ADDENDUM No. 2

**DOBBS BRANCH BASIN IMPROVEMENTS PHASE 1
CONTRACT NUMBER W-17-022-201**

CITY OF CHATTANOOGA, TENNESSEE

C - 506

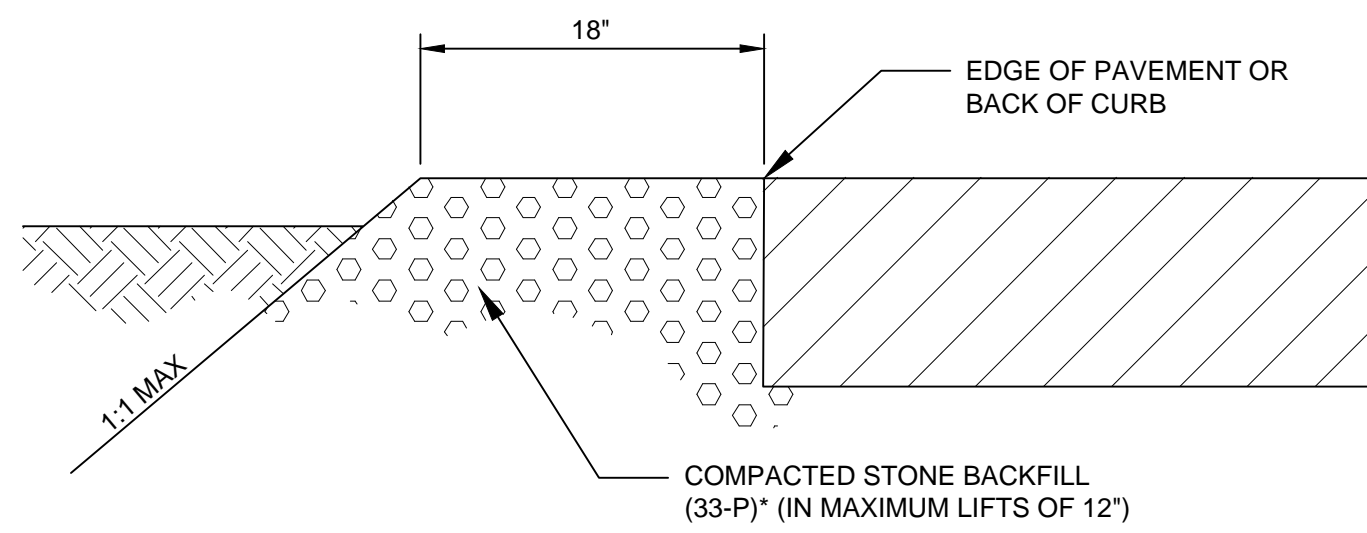
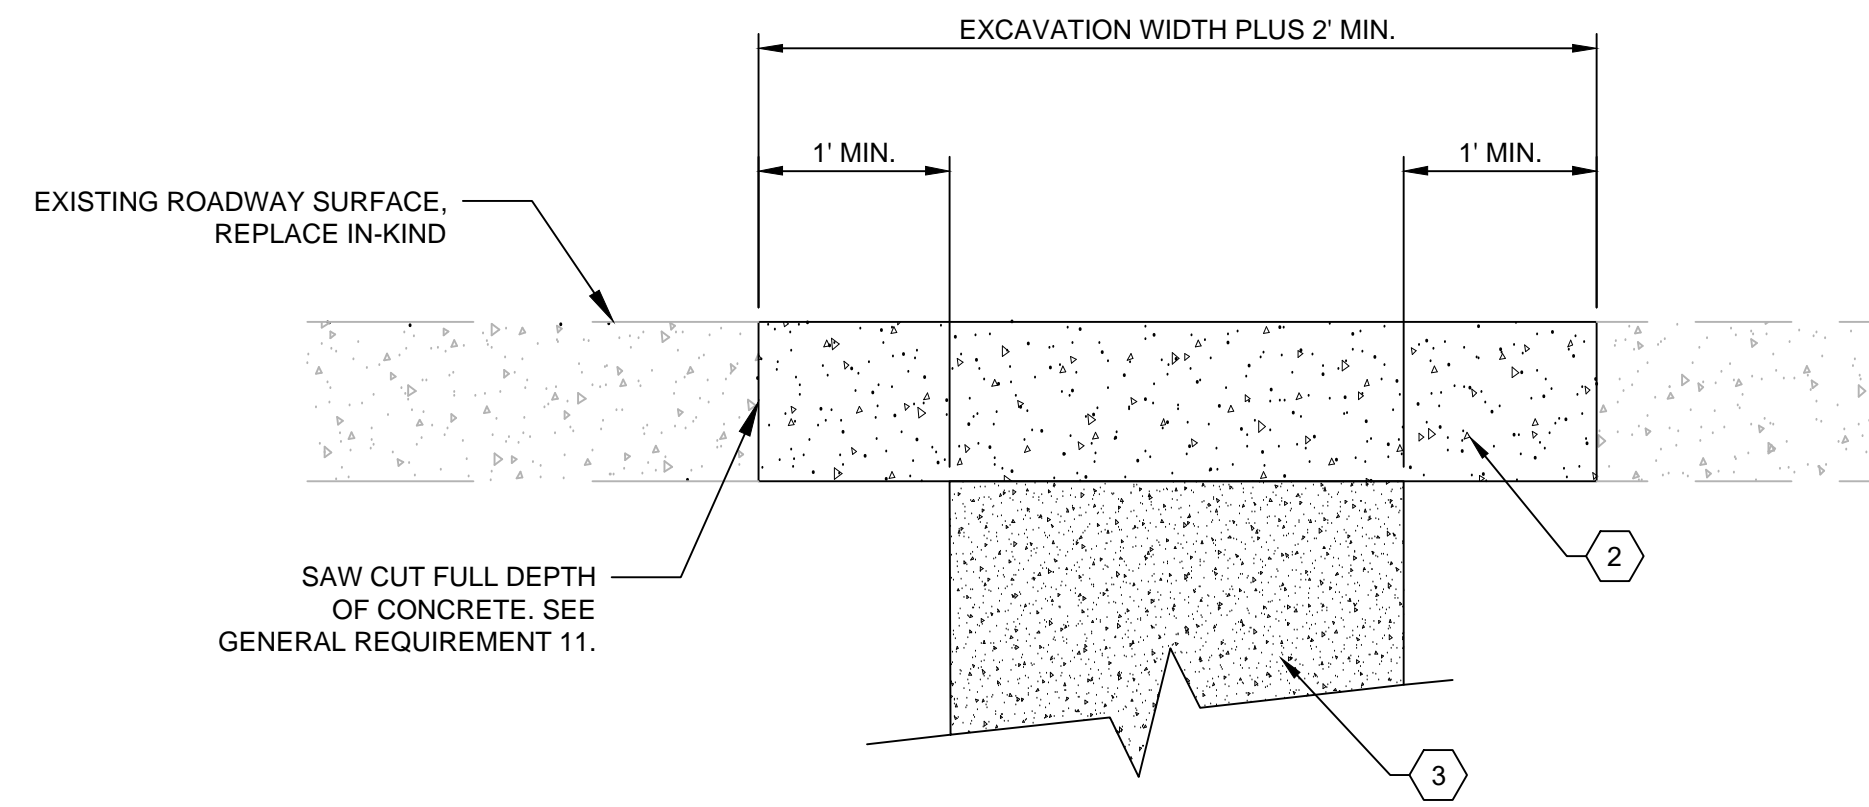
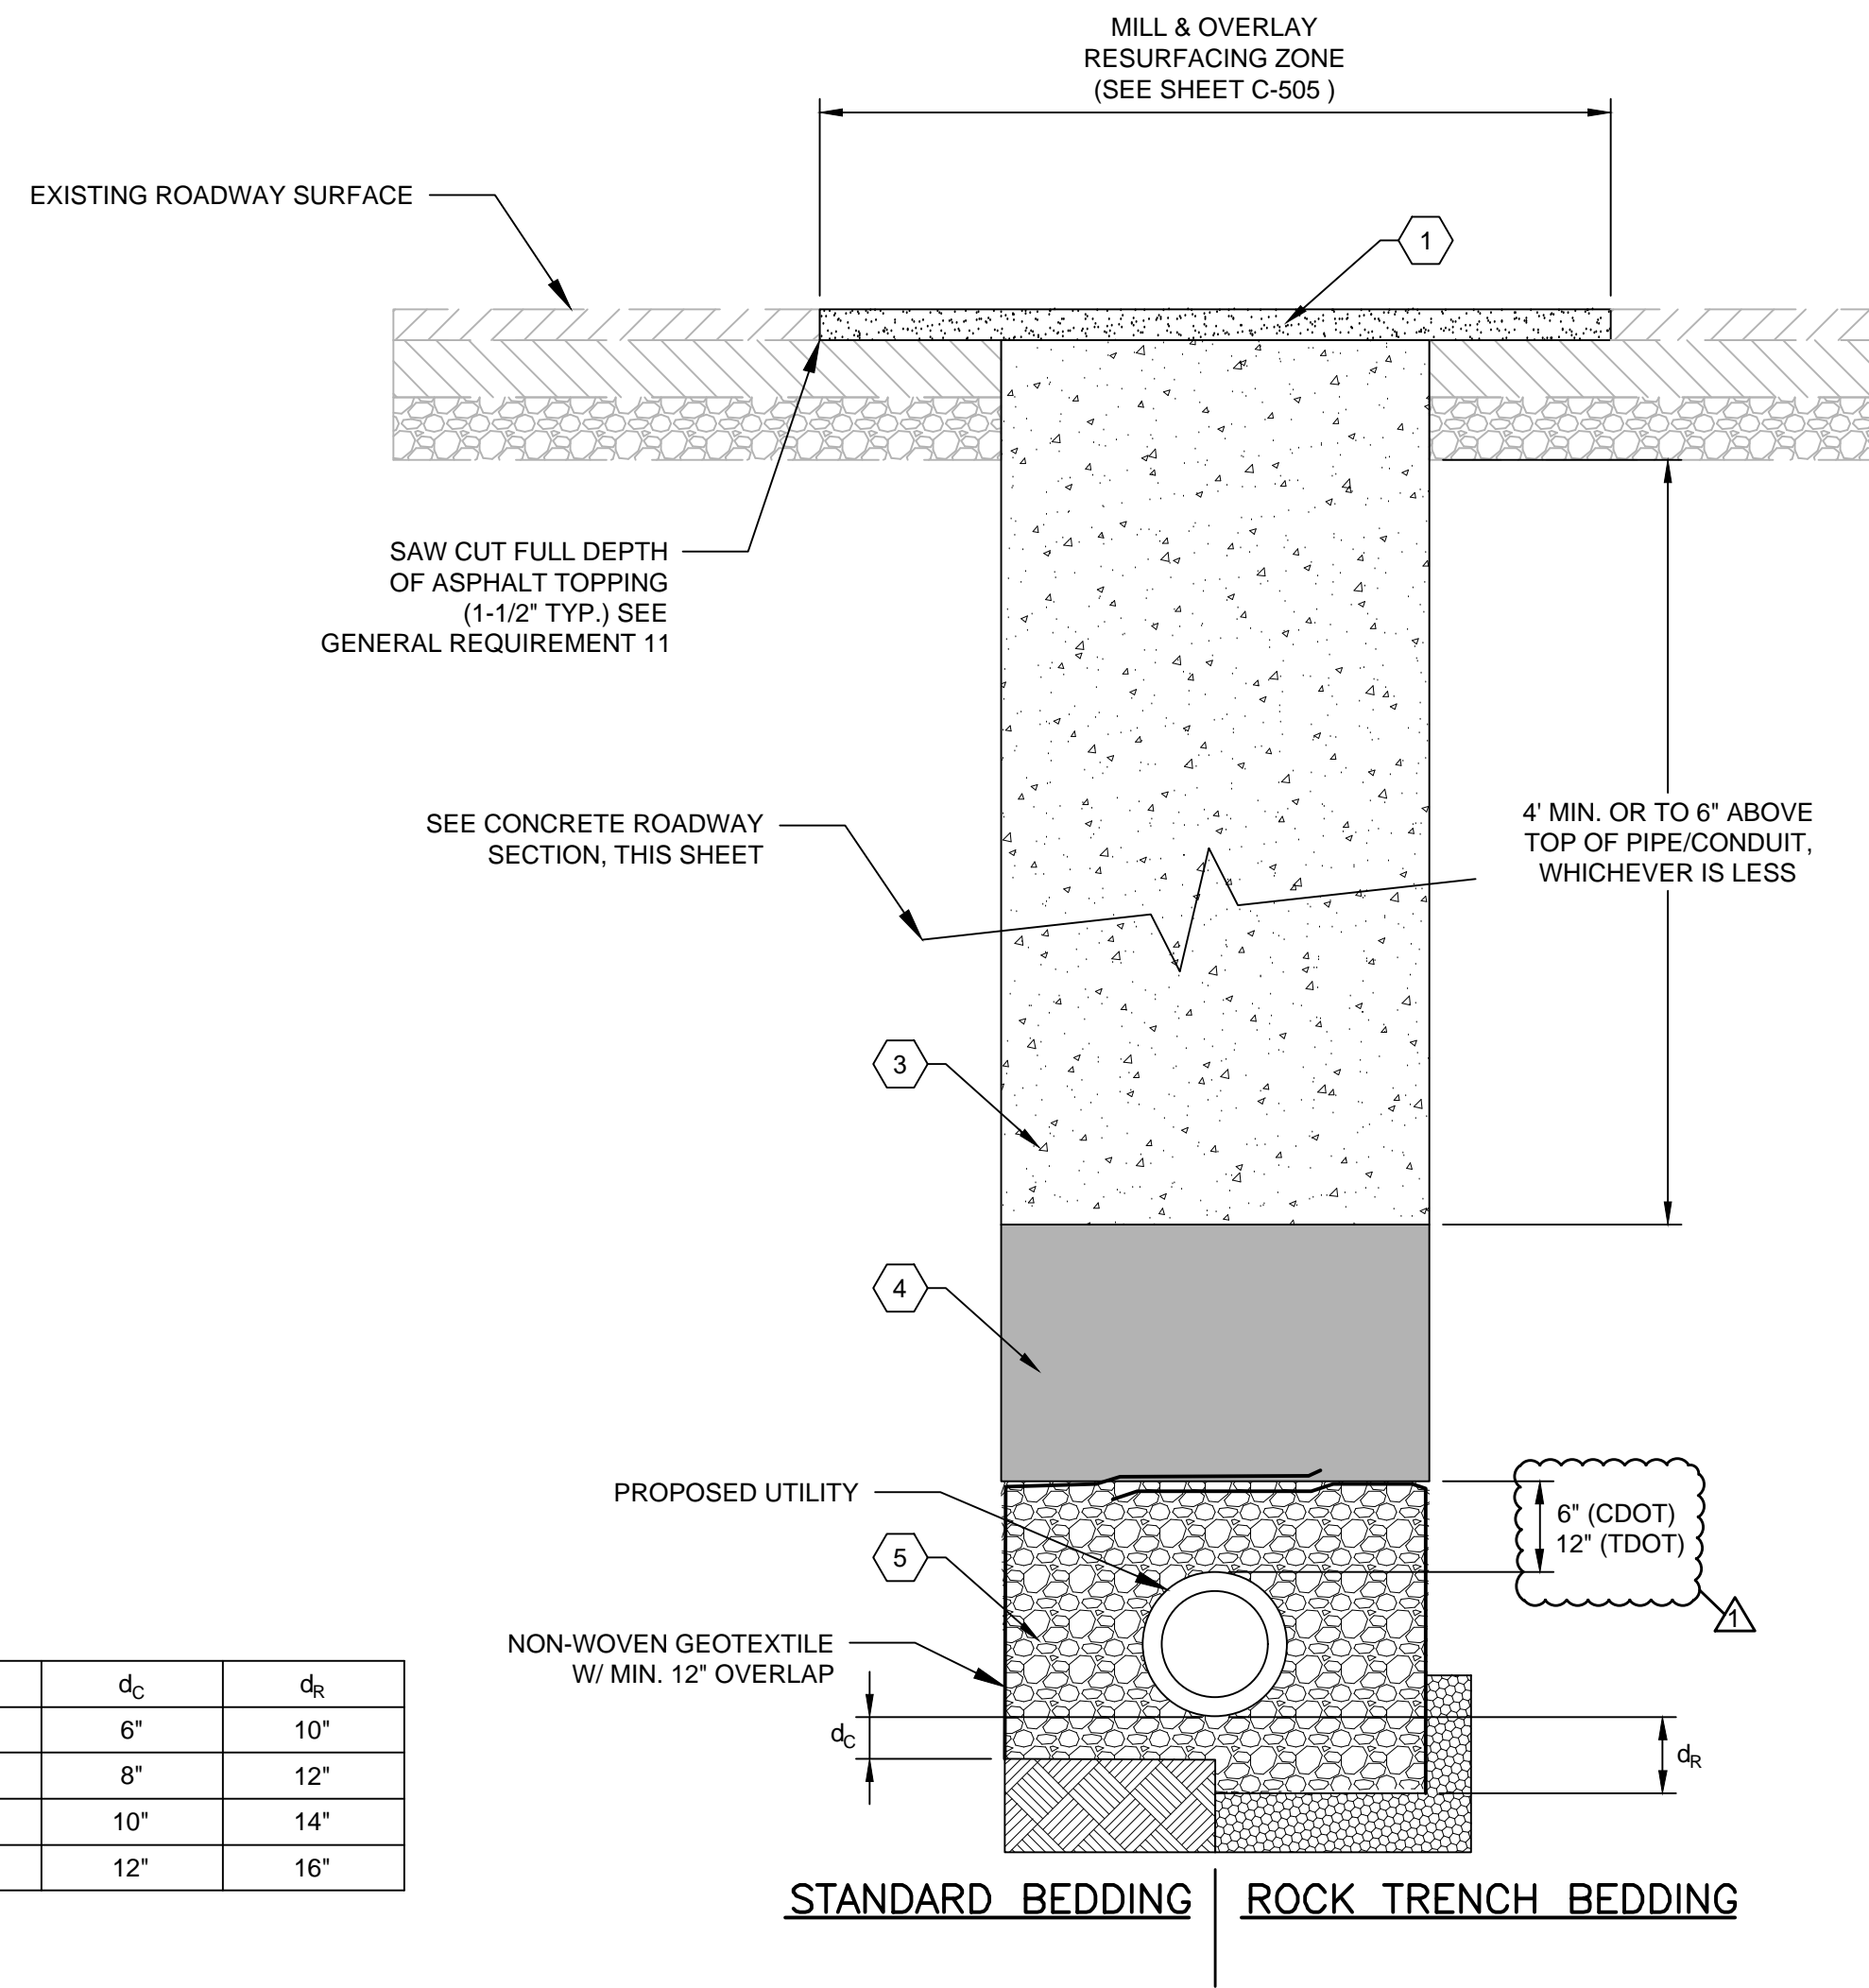
5. Contract Drawing C-506

Delete C-506 and replace with the attached revised drawing.

R5: Yes. See revisions to Drawings C-506, C-507 and Section 01 22 00 via addendum.
